Drain: KINGSBOROUGH DRAIN **Drain #:** 297
Improvement/Arm: KINGSBOROUGH - SECTION 3
Operator: SLM/JOH **Date:** 1-9-04
Drain Classification: Urban/Rural **Year Installed:** 1998

RE: Kingsborough Drain, Section 3 arm

Re: Kingsborough Drain: Sec. 3 Arm

SITE DEVELOPMENT PLAN
 KINGSBOROUGH SECTION THREE
 CARMEL INDIANA

STORM SEWER PLAN & PROFILE
KINGSBOROUGH SECTION THREE

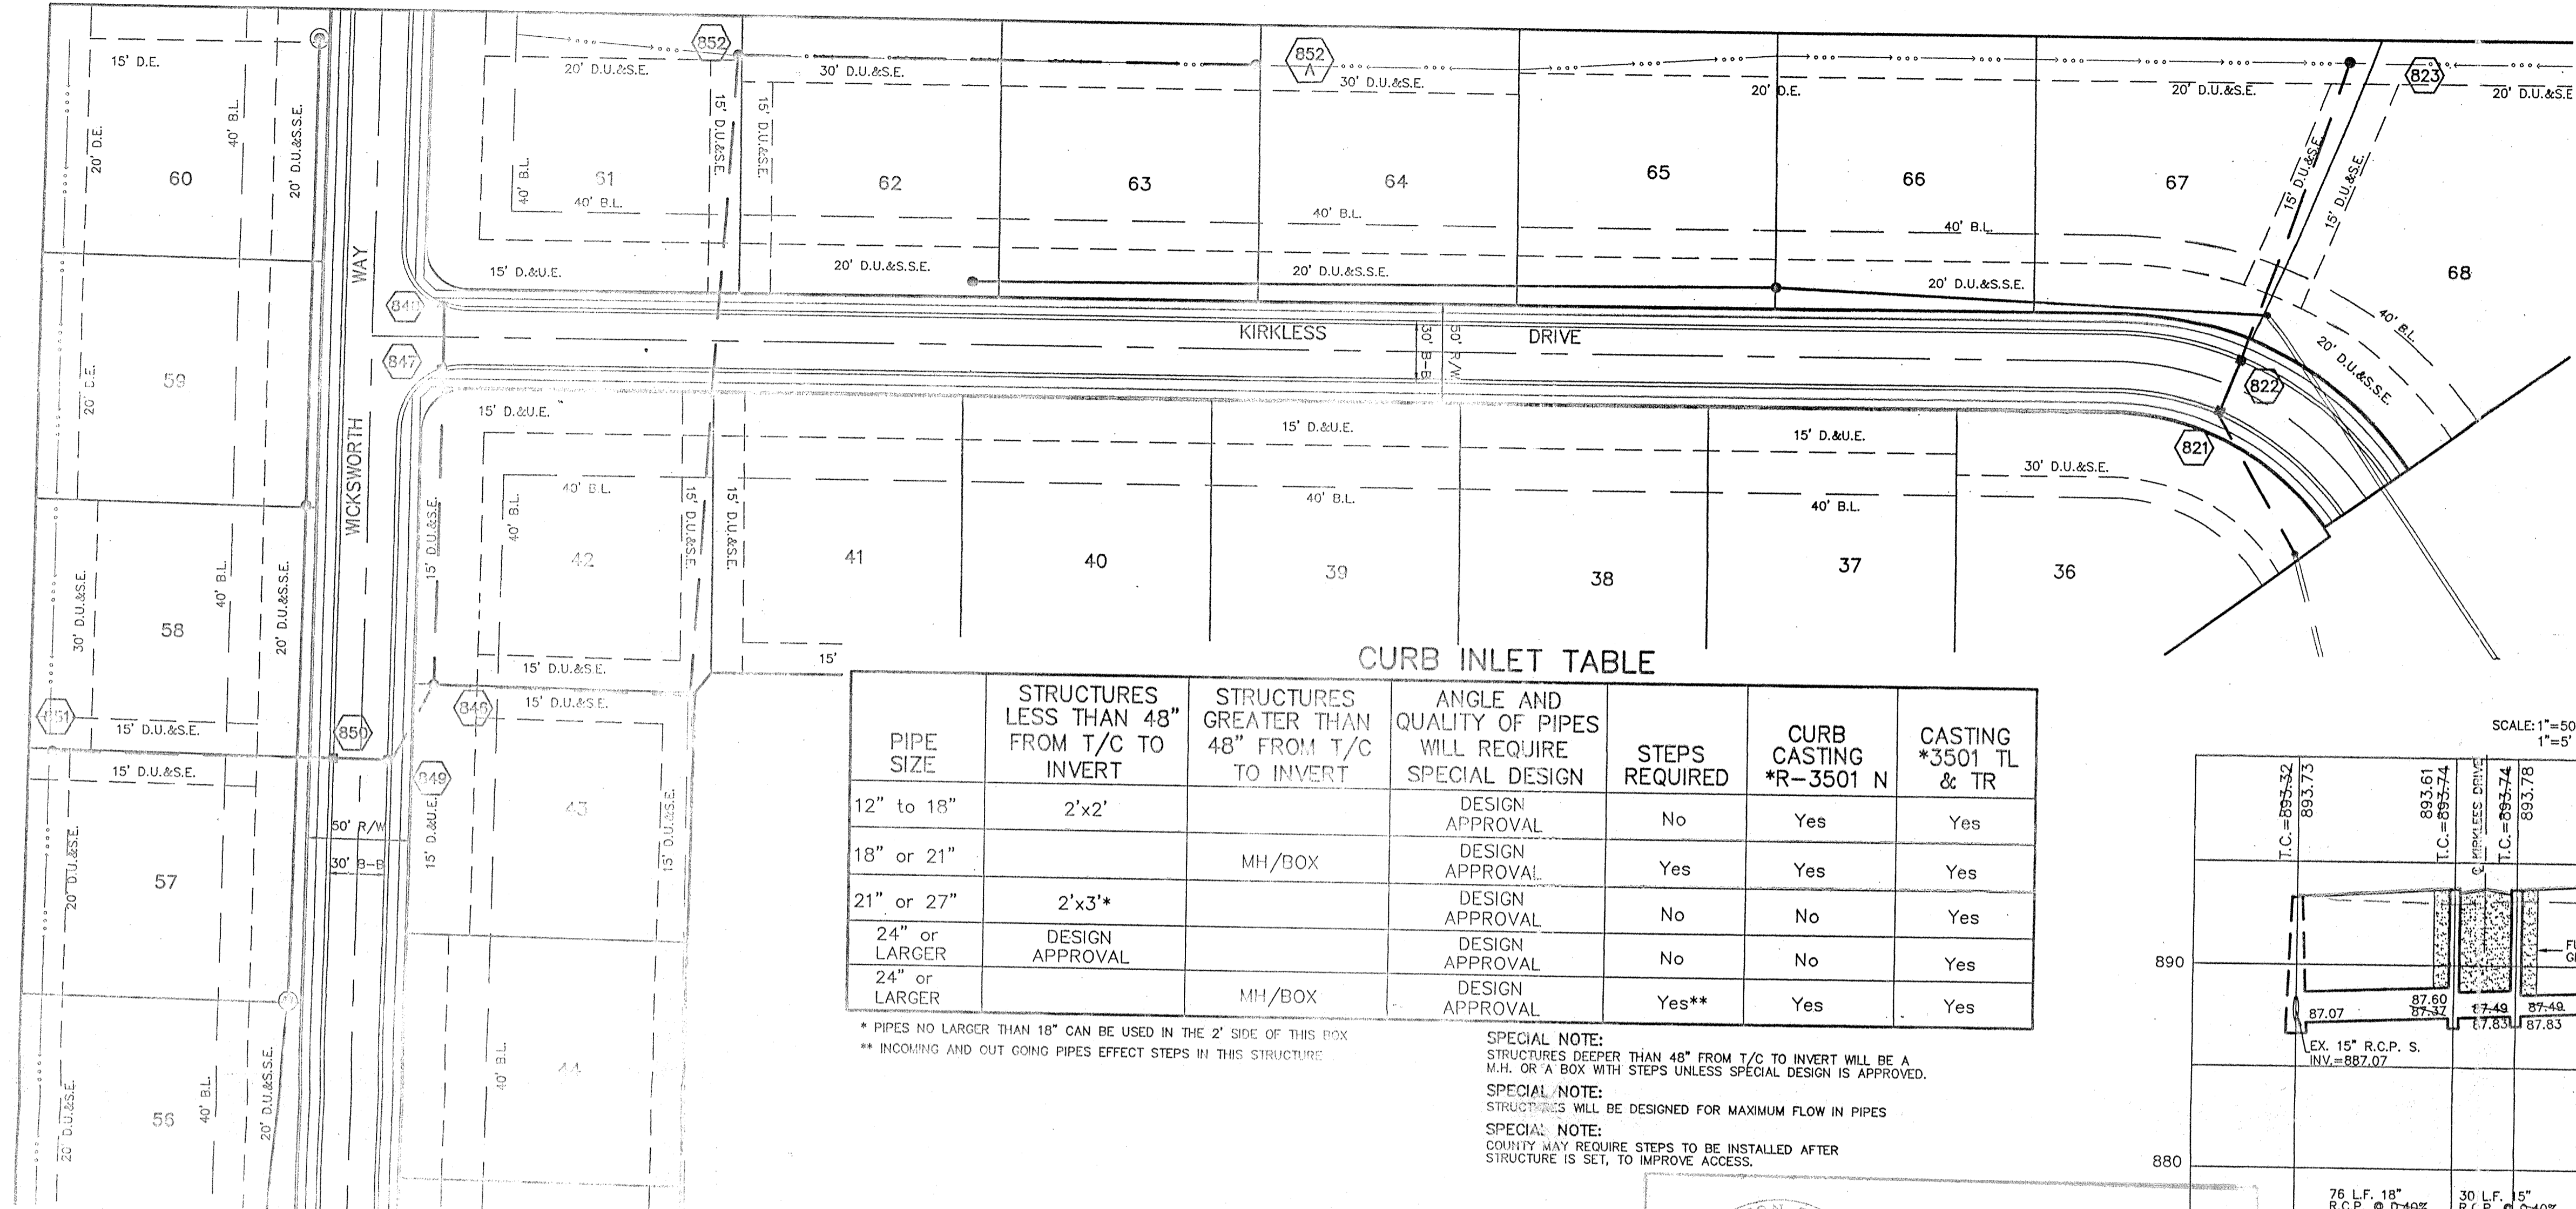
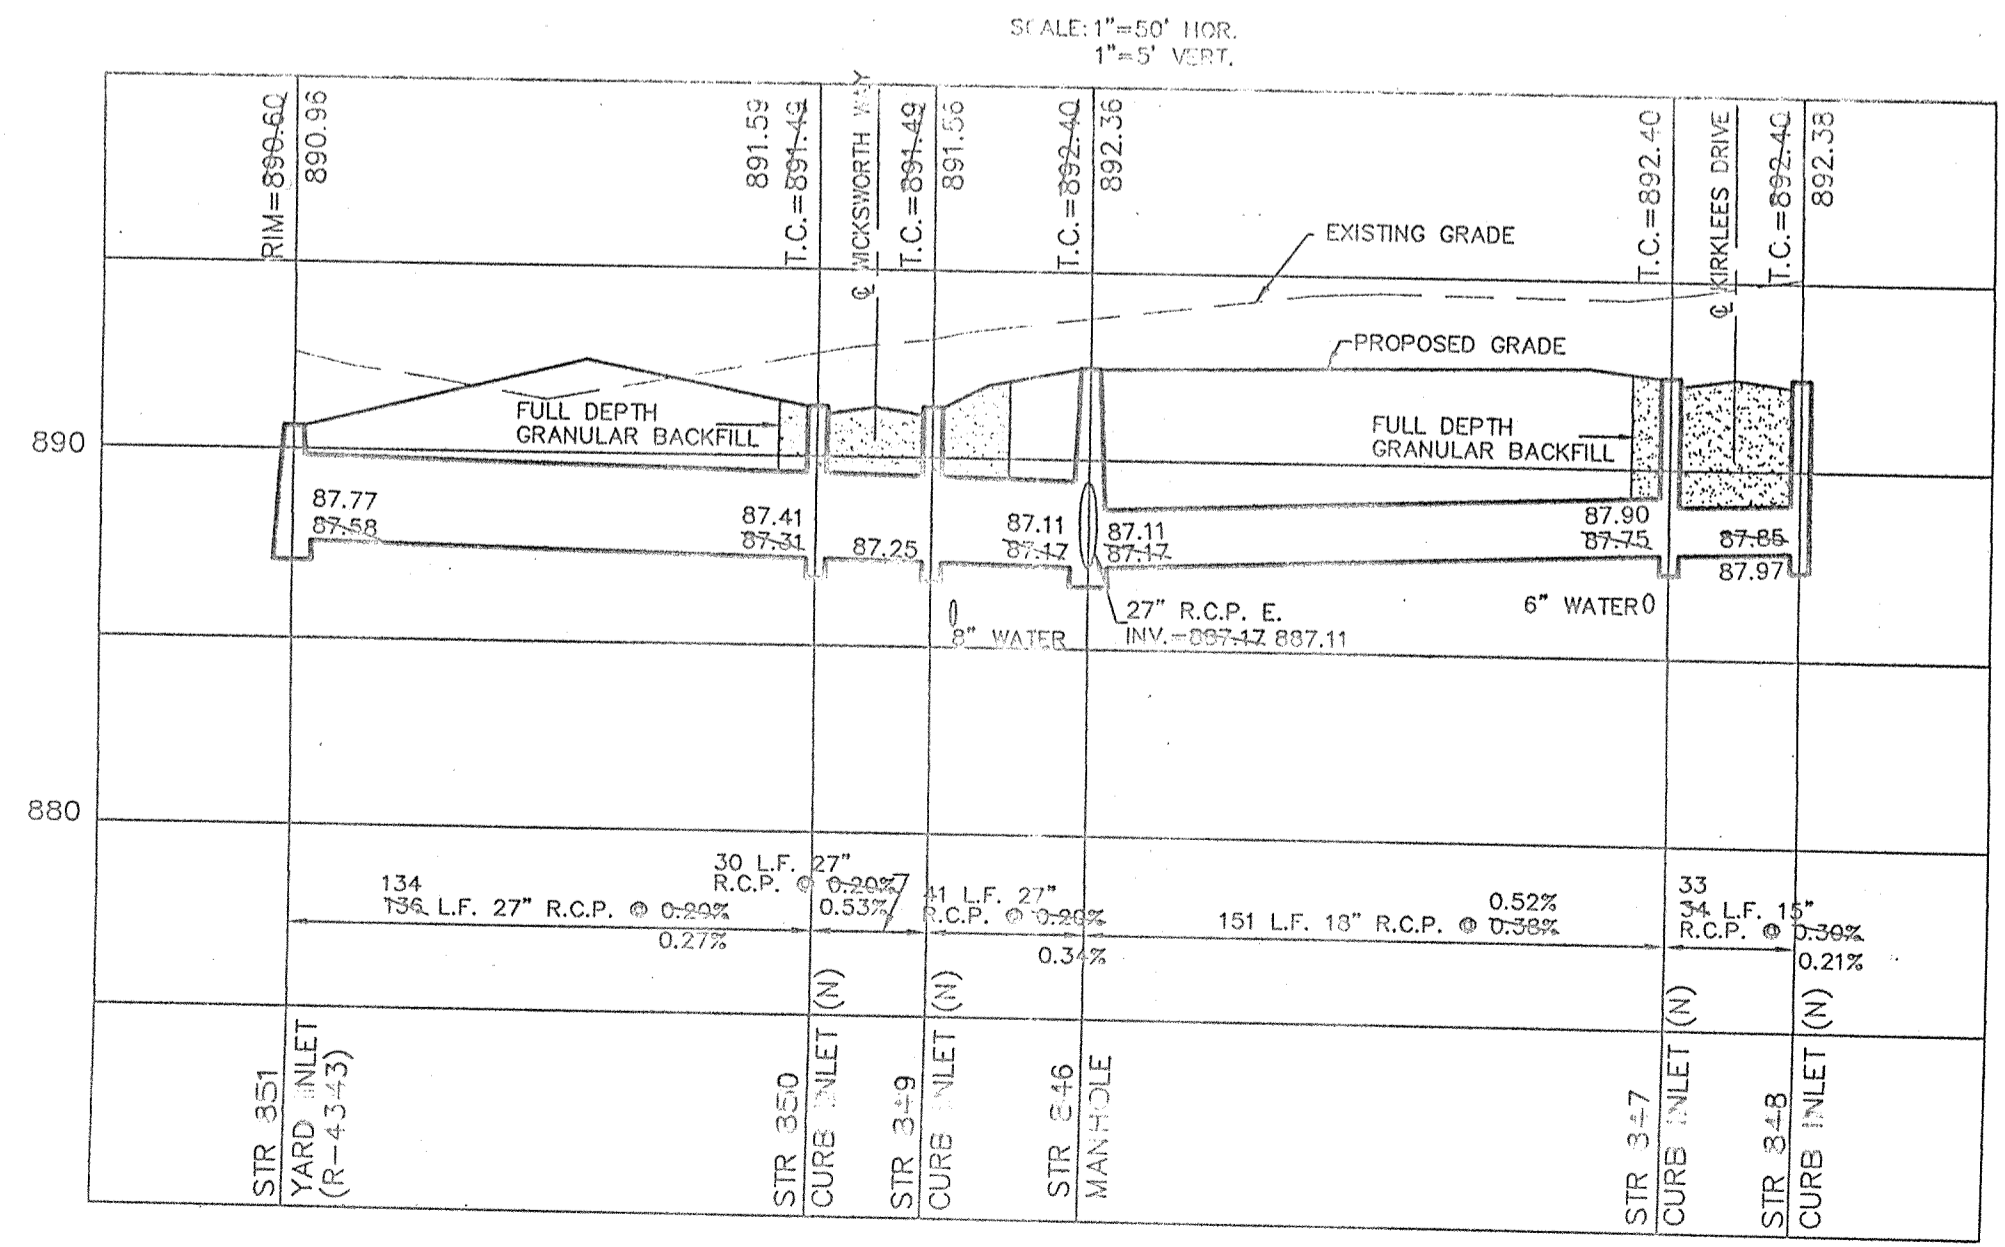
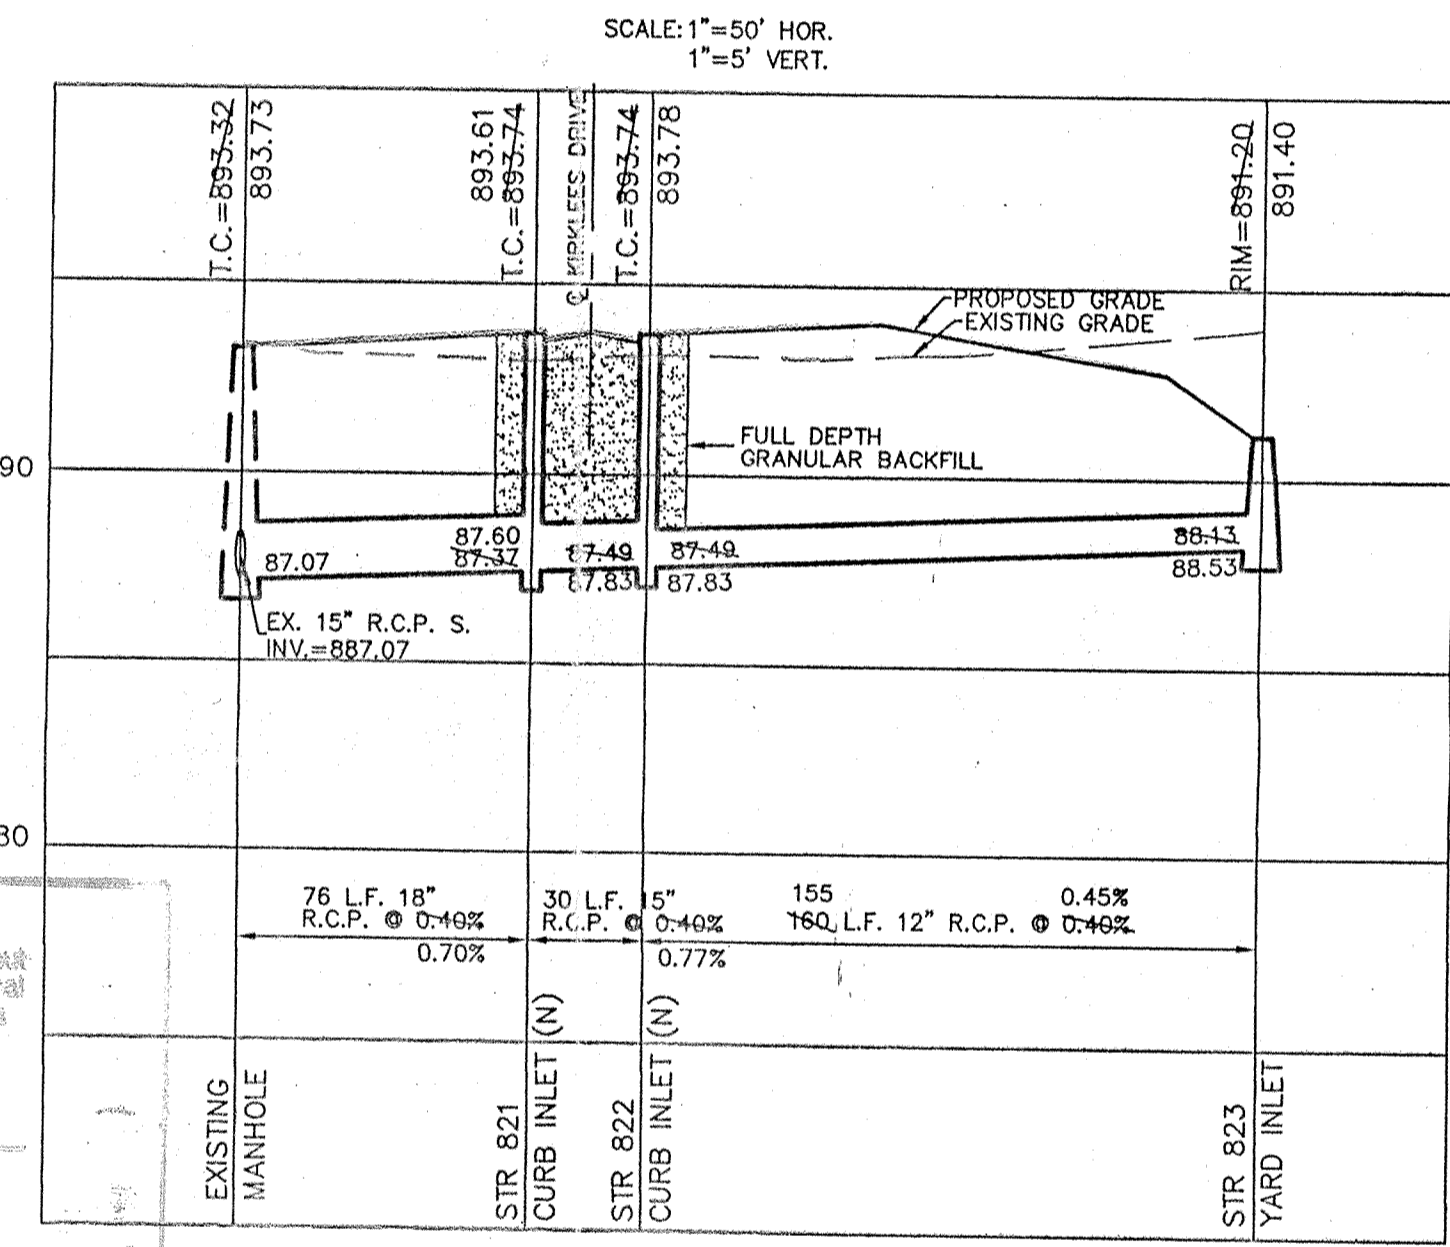
During construction, changes were made to the drain, which will alter the plans submitted with my report for this drain-dated October 15, 1998. The changes are as follows:

844	889.93					
	843	889.8		15	134		
	843	889.8					
	840	889.37		15	85	86	-1
	840	889.37					
EX. Yard Inlet		889.13		18	147	149	-2
	842	888.91					
	841	888.78		12	30		
	841	888.78					
Ex. Manhole		889.64		15	164		
	861	890.22					
	860	889.01		42	220	224	-4
	860	889.01					
860C				48	21	24	-3
	851	890.96					
	850	891.59		27	134		
	850	891.59					
	849	891.56		27	30		
	849	891.56					
	846	892.36		27	41

846	892.36					
847	892.4		18	151		
847	892.4					
848	892.38		15	33	34	-1
846	892.36					
EX. Yard Inlet	892.5		27	122	123	-1
EX. Yard Inlet	892.5					
852	892.68		18	315	314	1
852	892.68					
852A	893.78		12	250		
Ex. Manhole	893.73					
821	893.61		18	76		
821	893.61					
822	893.78		15	30		
822	893.78					
823	891.4		12	155	160	-5

The length of the drain due to the changes described above is now ^{6319'}~~6,199~~ feet.
